UNITED STATES PATENT AND TRADEMARK OFFICE

| Office Action Summary | Application No. 10/606,110 | Applicant(s) YOUN, KARP-SIK | |

TITLE: APPARATUS FOR AND METHOD OF PREVENTING PAPER DOUBLE FEEDING IN PRINTER

FIG. 10

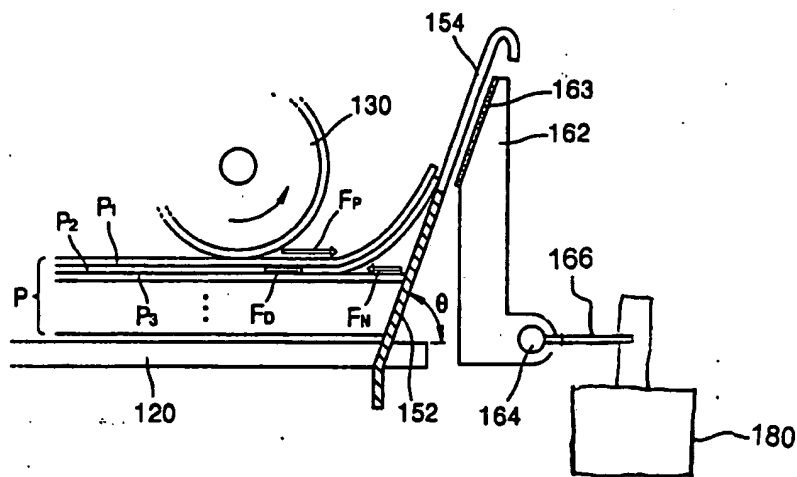
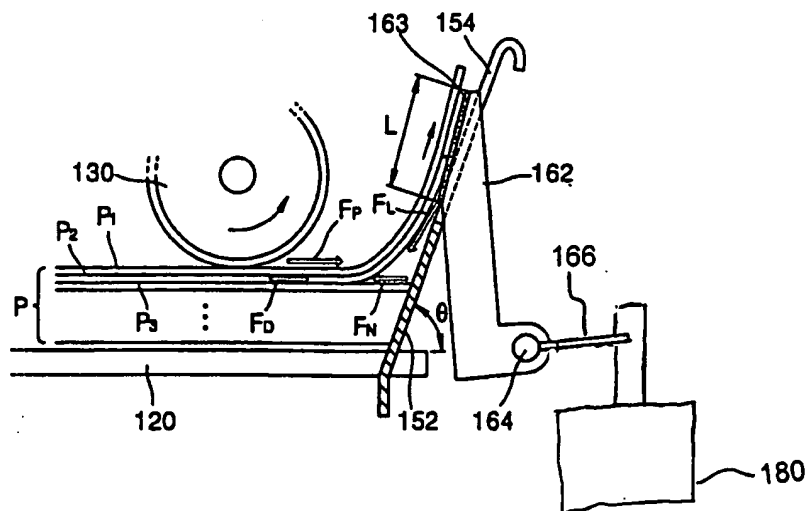
1. The drawings were received on 09/01/2006. These drawings (i.e., newly added Figures 10 and 11) have not been entered, because they introduce new matter. In particular, newly added Figs. 10-11 show details of how a solenoid 180 is arranged and connected to a shaking plate 166, which is not supported by the disclosure of the instant application. Thus, the newly added drawings (i.e., Figs. 10 and 11) have not been entered.

3. The amendment filed 09/01/2006 is objected to under 35 U.S.C. 132(a) because it introduces new matter into the disclosure. 35 U.S.C. 132(a) states that no amendment shall introduce new matter into the disclosure of the invention. The added material which is not supported by the original disclosure is as follows: (1) the amendment to numbered paragraph [0032] describing new Figures 10 and 11; and (2) the amendment to numbered paragraph [0047].

DO NOT ENTER
Yam 11/13/06

Applicant is required to cancel the new matter in the reply to this Office Action.
